Our Ref: 11771 Submission June 2024

RE: DA 2024/0155 Use of Premises as an educational establishment and associated external and internal alterations

Property: 35 Consul Road, Brookvale St Augustine's College Brookvale

Figure 1 Front Elevation relative to Flood Levels

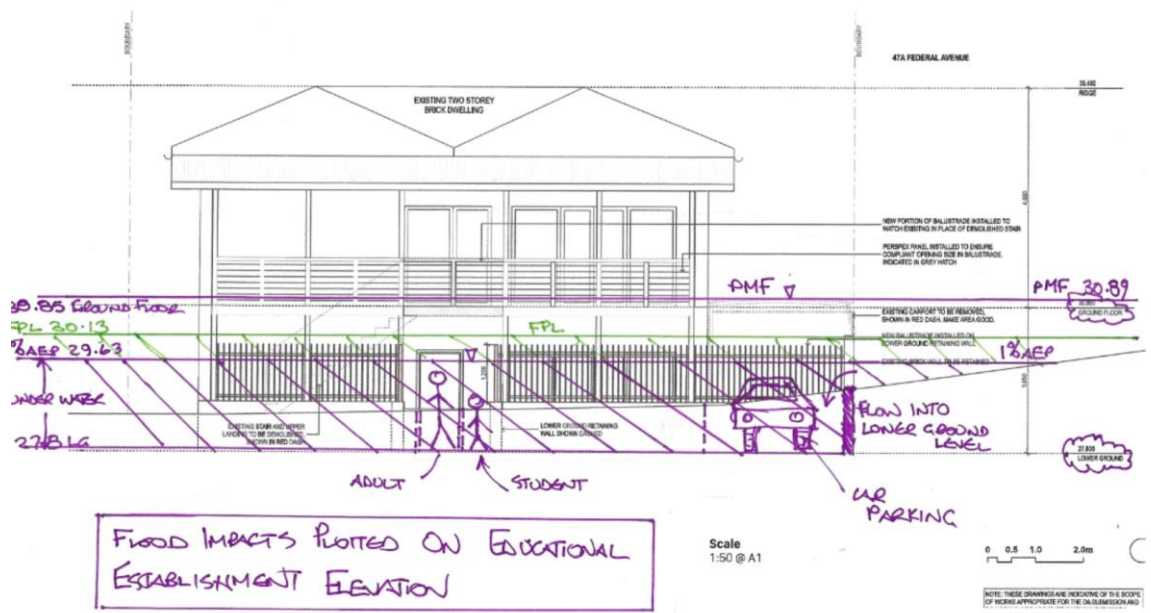
The site is identified within the Brookvale Creek Flood Study as being located within the High and Medium Risk Flood Planning Precincts. The proposal seeks approval for the use of the existing dwelling house as an ancillary office use and that students will not be permitted within the property. My client (a qualified civil engineer) has prepared diagrams indicating the extent of the flooding relative to the floor levels of the existing dwelling house.

Figure 2 Section showing driveway and rear yard relative to flood levels

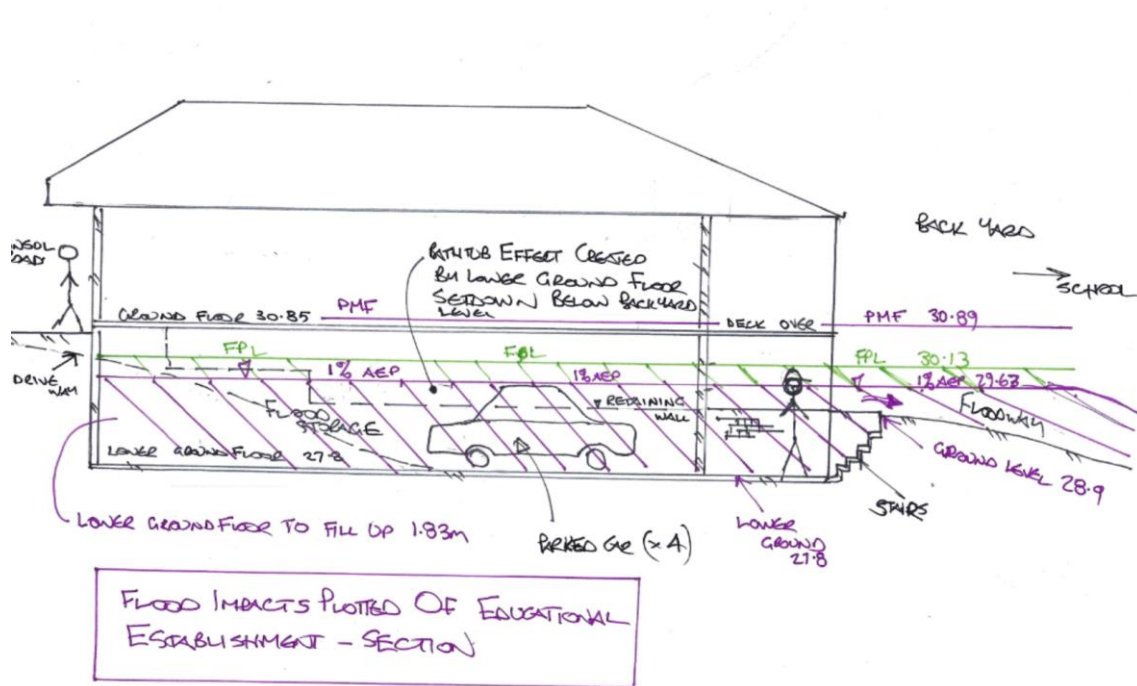
- The structural adequacy of the building has not been established to withstand the potential impact of vehicles proposed within the driveway against the dwelling house in the event of a flood event. In the absence of the structural integrity of the dwelling house being established, all parking should be removed from the site to effectively reduce the risk. Notably, the proposal seeks to provide for parking for 4 vehicles increasing from the 2 required for the existing residential use.

Figure 3 Figure 12 of Flood Management Report

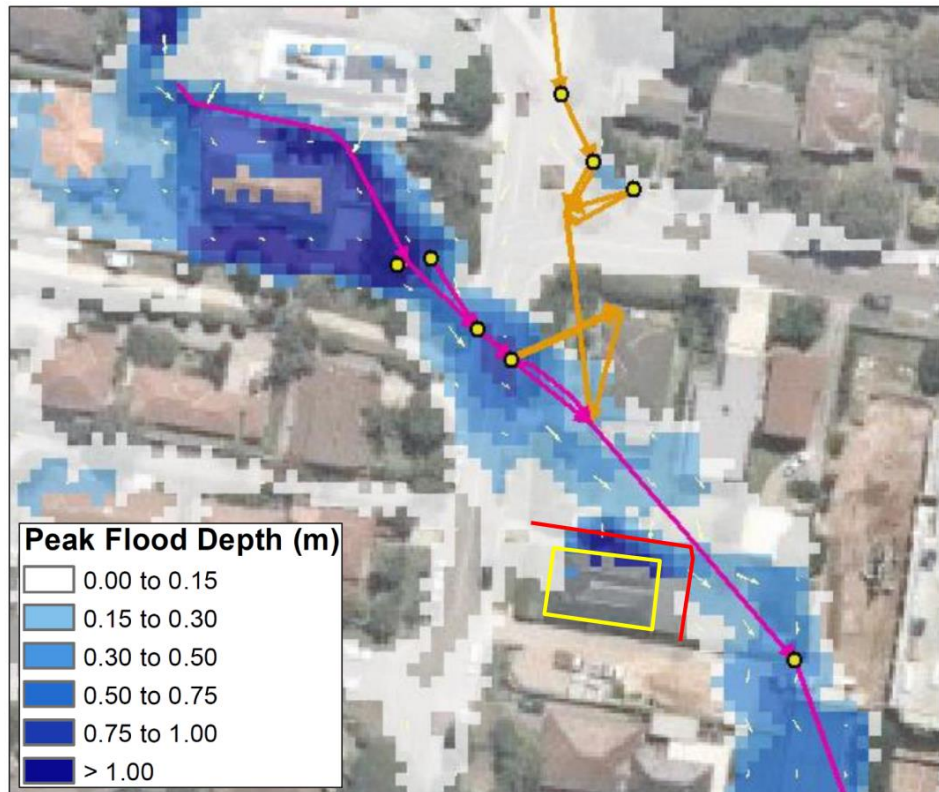
- Does not consider future use of the site for educational establishment.
 - References "*the existing brick retaining wall as protecting*" "*from the 1% AEP flooding*". Figure 12 indicates that there is a retaining wall as shown in red below. These references appear to be a misunderstanding as to levels of the land and existing improvements. Additional survey to confirm and document the above should be provided.

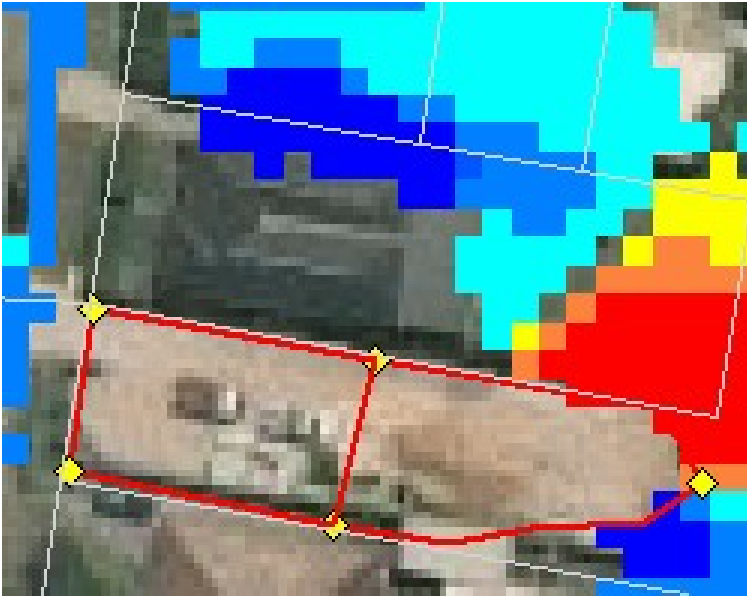
Below is a zoom in of the 1% AEP flood depth in the vicinity of this location with the updated terrain in this location (zoom of Figure D6). The 1% AEP flood depth on the downstream side of the constriction still reaches over 0.7m deep (up to 0.6m deep on 31 Consul Road).
